DUANE ARNOLD ENERGY CENTER

AMENDMENT TO FACILITY OPERATING LICENSE

Amendment No. 33
License No. DPR-49

SUPPORTING AMENDMENT NO. 33 TO LICENSE NO. DPR-49

FIGURE 3.12-5

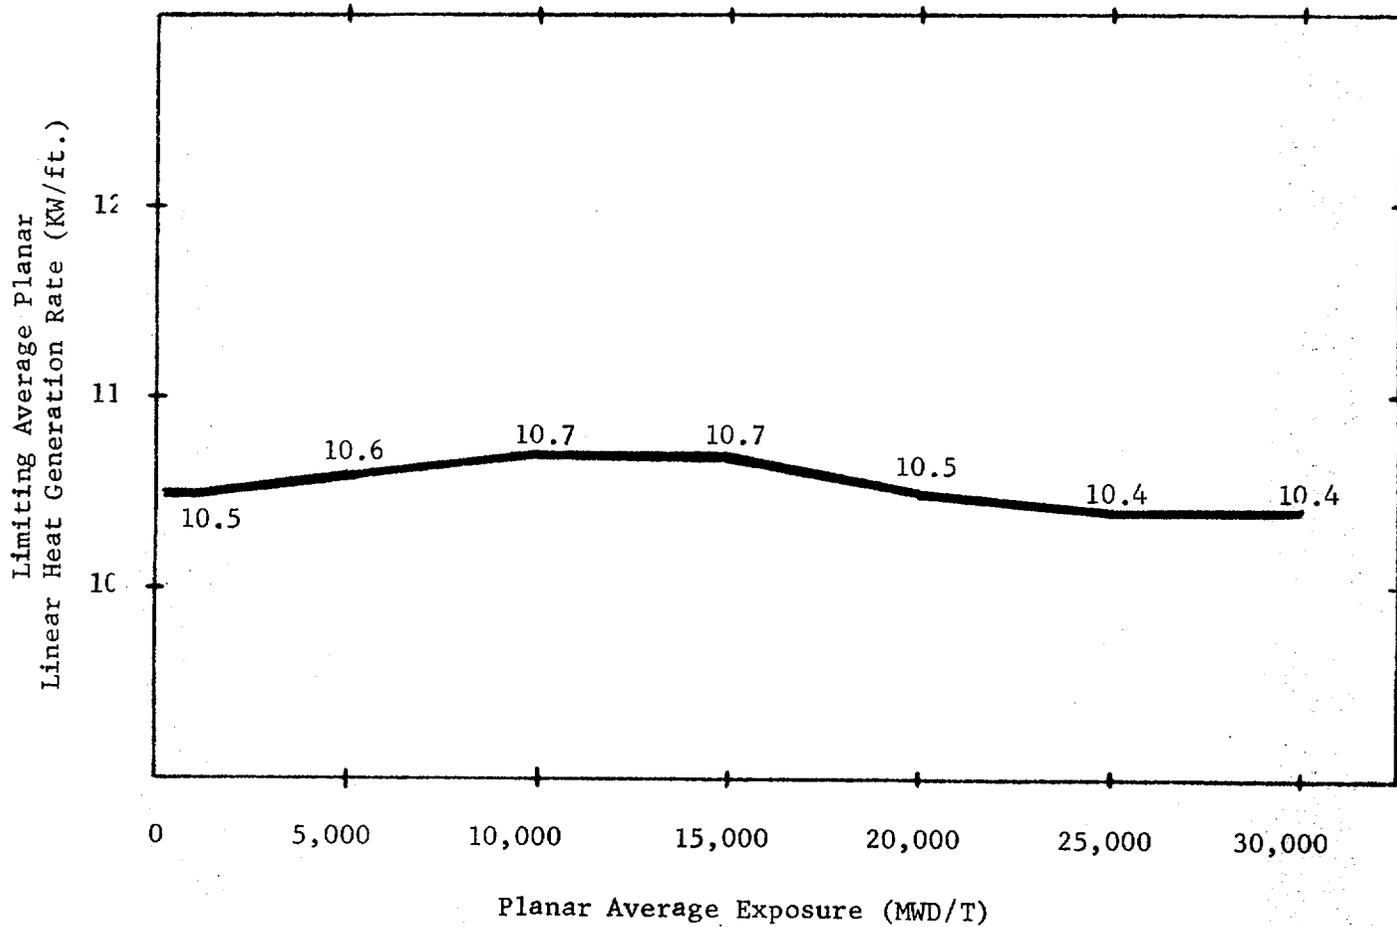
The loss-of-coolant accident was reanalyzed for the 8D274 fuel with the results presented in Reference 2. The analysis indicated compliance with Section 50.46 criteria and Appendix K to 10 CFR Part 50. The Technical Specification changes⁽¹⁾ include MAPLHGR limits for the 8 x 8 fuel (Technical Specification Figure 3.12-5) which are appropriate for this analysis; and thus are acceptable.
